**RE: Eversource Notice of Intent
50 Duchaine Boulevard – New Bedford, MA**

**RE: Response Letter
Eversource Project
Duchainne Blvd., New Bedford, Massachusetts**

We have enclosed a response letter, revised Site Plans, SWPPP and stormwater calculations in response to the comment letter prepared by Nitsch Engineering dated January 17, 2017 in regards to their review of the Site Plans.

Nitsch Engineering Comments

POST-DEVELOPMENT
DRAINAGE MAP
SHEET 5A OF 9

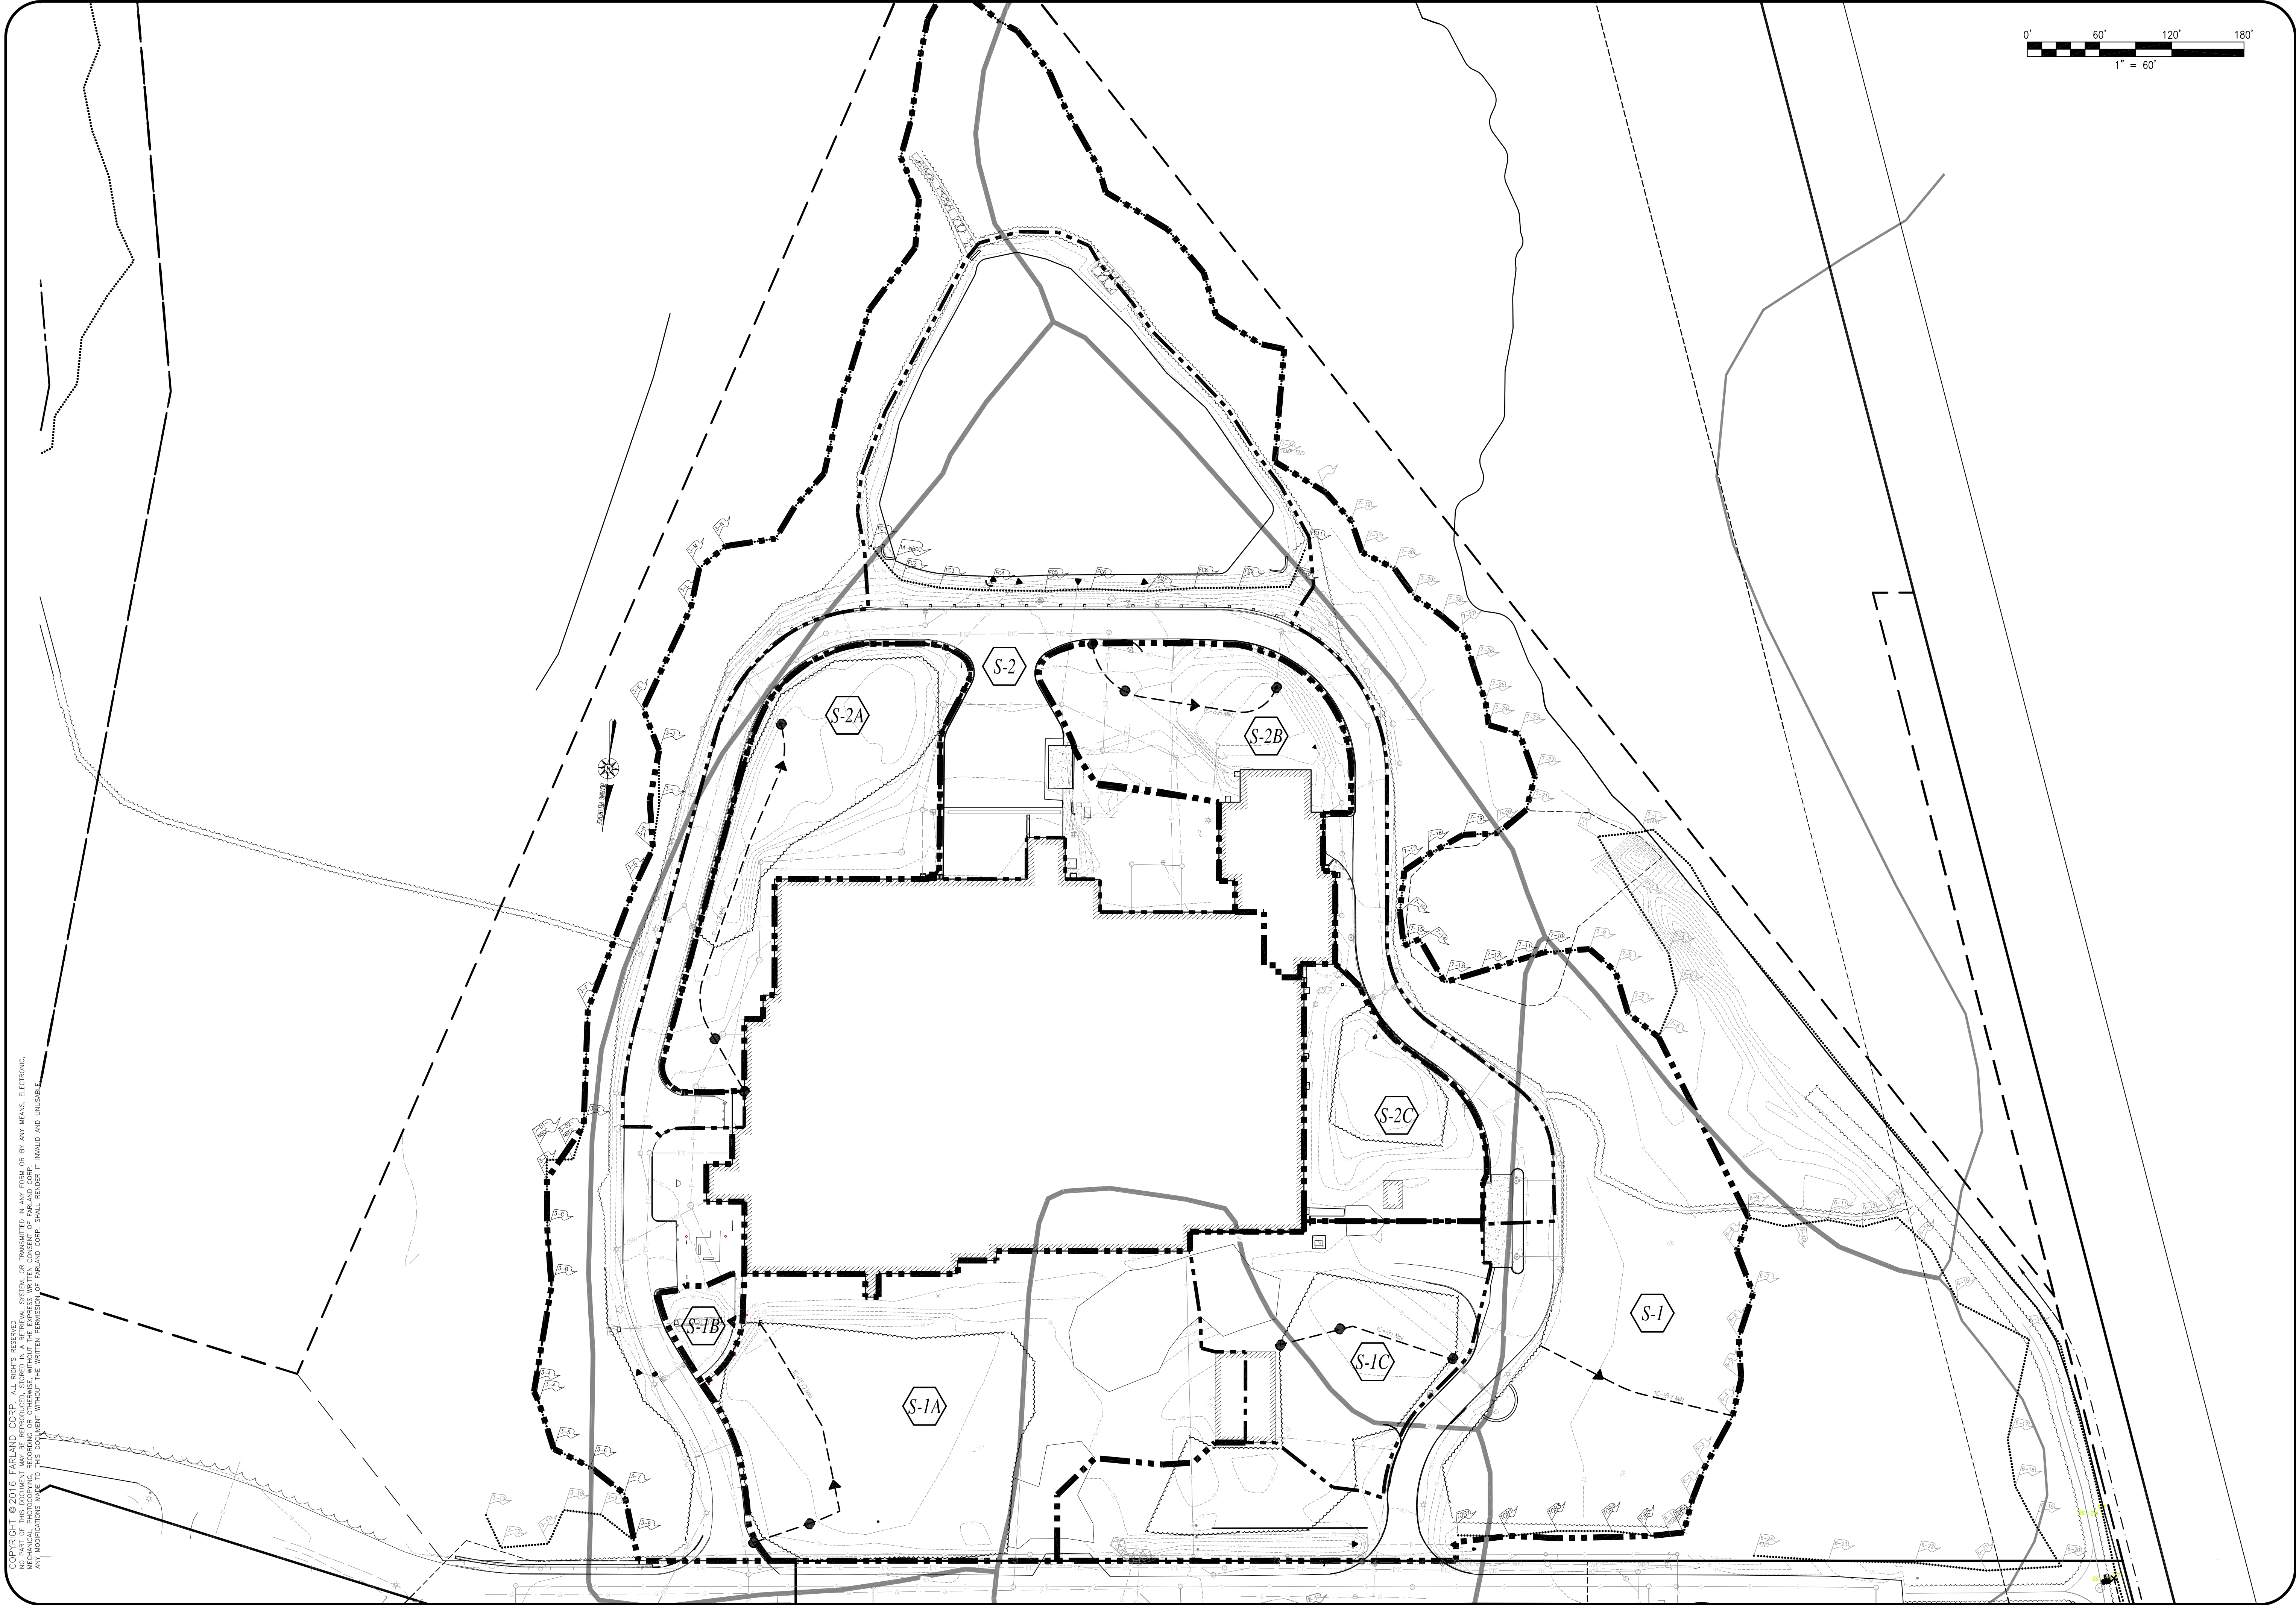
In the proposed conditions HydroCAD model, the time of concentration for subcatchment S-10 (proposed parking lot) is listed as 16 minutes. We recommend that this be revised to 6 minutes, consistent with the MassDEP stormwater handbook and standard engineering practice for paved areas.

Farland Corp. (FC) has revised the Tc as requested.

18 INFILTRATION BASIN
7 NOT TO SCALE

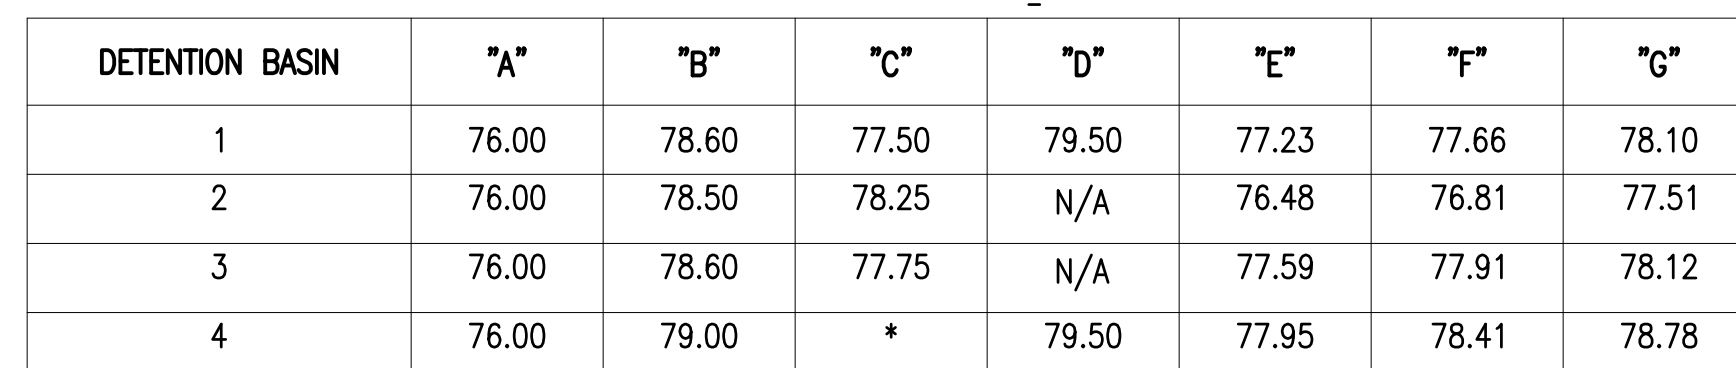
The table in the infiltration basin detail should be reviewed for consistency with the HydroCAD model. Some of the elevations for the overflow berm appear to be different. We would also recommend adding these as spot grades to the Grading Plan.

FC has revised the basin detail and added spot grades as requested.
